UNITED STATES PATENT AND TRADEMARK OFFICE

**Advisory Action**

09/911,949

RUSSO, THOMAS LOUIS

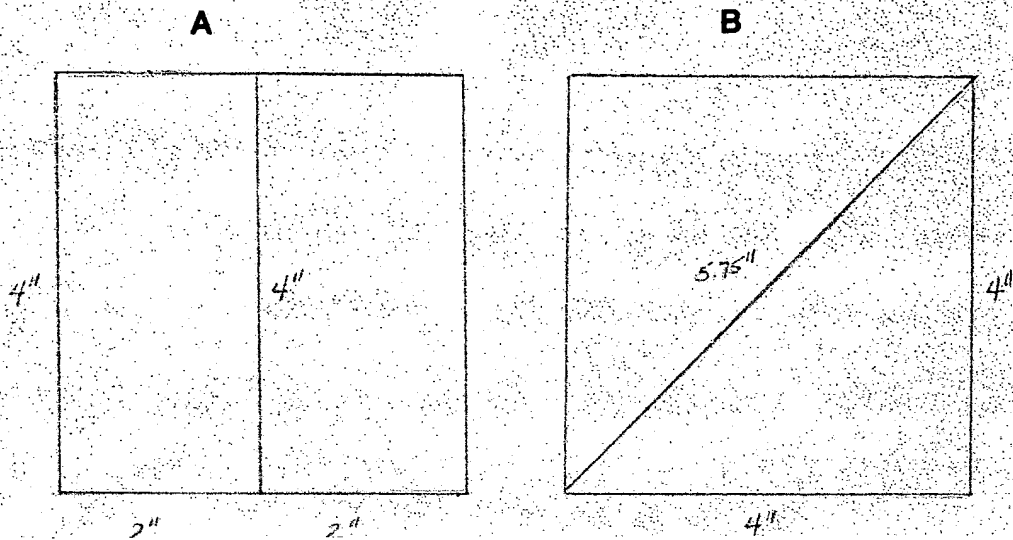
Jaszai discloses the claimed wrapping system above including the chambers maximizing available pad surface (Figure 20, #14); however, Jaszai fails to disclose the chambers being substantially conical in shape.

I reviewed your suggested section (Column 7 lines 33-35, FIG 20,#14)" into two wall chambers 14 is arranged in a continuous zigzag. Each wall chamber 14 elongated in zigzag is subdivided into generally U-shaped compartments by intermediary taps 9." a did note that Mr. Jaszai did describe a specific shape of each compartment as U shaped and that the subdivision was created by a zigzag design format. That allow me to understand that our compartments were cone or triangle shape and that we had a specific triangle or cone pattern to develop our subdivision of our pads. And that a cone shape would not work with Mr. Jaszai's format because our cone or triangle designs have a base end on one pad perimeter and the top end of the cone or triangle at the opposite perimeter . Cone shape chambers allow our pad to present a higher profile, because pad height is determine by the smallest chamber dimension.

The sketch above will hopefully help illustrate the statement that a chamber height is determined by its smallest dimension. A and B represent a four inch square, consider then inflatable pads. When we divide pad A in half using a rectangle chamber like Mr. Jaszai's wrapping pad the smallest dimension is 2 inches, but when you use a cone shape or triangle shape similar to pad B like our pad the smallest dimension is 4 inches. The cone shape does make a significant difference in obtaining a higher pad profile providing a void fill pad with greater impact protection and requiring less void fill pads to pack like shipping boxes using lower profile pads.

Ms. Nordmeyer, will that example be sufficient to allow me to use shape as an important part of my invention?

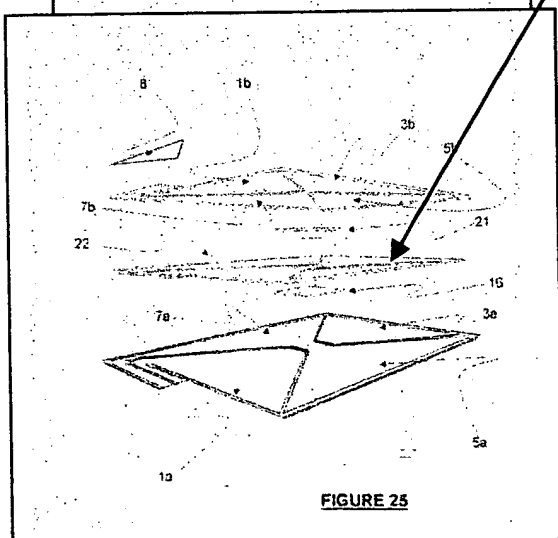
Magid discloses a central wall member made from film (Column 4, lines 52 – 54), where individual sheets of plastic are placed next to each other and sealed to the central layer (Column 4, lines 54 – 56), forming a first layer through heat-sealing along the perimeters (Column 4, lines 30 – 33) making separate inflatable areas (Figure 4, #22 and Column 4, lines 54 – 56) which form an impact resistant wrapping, packing, system. The inflatable article contains an intake tap for each of the separated inflatable areas (Column 4, line 56 and Figure 4, #23). Each area is inflated or deflated independently through intake and exhaust taps located in the perimeter of the article (Figure 4, #23), allowing the wrapping system to be reused (Column 6, lines 60 – 65). However, Magid fails to disclose a second layer on the opposite side of the central layer to form at least four separate areas within the inner pad volume.

Magid discloses the claimed invention except for a second layer on the opposite of the first layer which formed separate areas on the pad surface. It would have been obvious to one having ordinary skill in the art at the time the invention was made to place individual sheets of plastic material on the opposite side of the central layer which are sealed to the central layer to form inflatable areas having their own valve control on the surface of the article, since it has

Magrid's central film 20 mentioned is a single film that separate chambers 22 are attached to, each with a separate valve 23.

Each chamber would need to be inflated and deflated independent of all others, defeating the purpose of air being able to move to another chamber in a zone when impact occurs. Chambers under impact pressure may simply bust causing the package to move possibly impacting other chambers destroying the integrity of the packing system

My central film is actually a complete third film layer the same size as both outer layer films positioned in between the two outer film layers, creating four separate zones , two zones above the central layer and two zones below the central layer. Creating an even more impact resistant pad because now an impact on a zone is cushioned by the separate zone below, spreading the force of the impact over several other zones. It is still designed to be filled when constructed and can be reused in that state. Or can be deflated by cutting open the portal tube and reused at a later time by simply blowing on the portal tube that fills all zones and all chambers in one action.

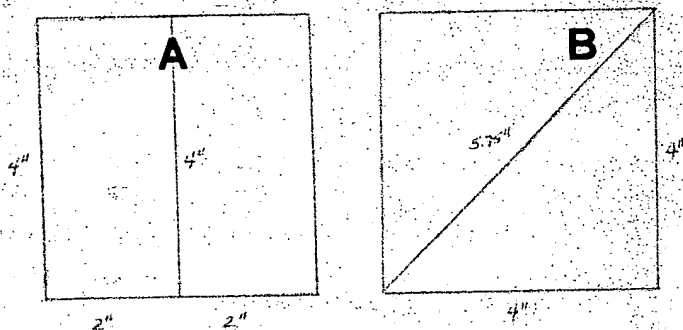
The examiner states, That shape is not relevant in my invention over Mr. Jaszai and Mr. Magid, but it certainly is relevant without the conical shape my pad does not work, Mr. Jaszai and Mr. Magid do not require a conical shape for their inventions to work. If my invention does not work without the conical shape it must have some relevance.

The sketch above will hopefully help illustrate the statement that a chamber height is determined by its smallest dimension. A and B represent a four inch square, consider then inflatable pads. When we divide pad A in half using a rectangle chamber like Mr. Jaszai's wrapping pad the smallest dimension is 2 inches, but when you use a cone shape or triangle shape similar to pad B like our pad the smallest dimension is 4 inches. The cone shape does make a significant difference in obtaining a higher pad profile providing a void fill pad with greater impact protection and requiring less void fill pads to pack like shipping boxes using lower profile pads.
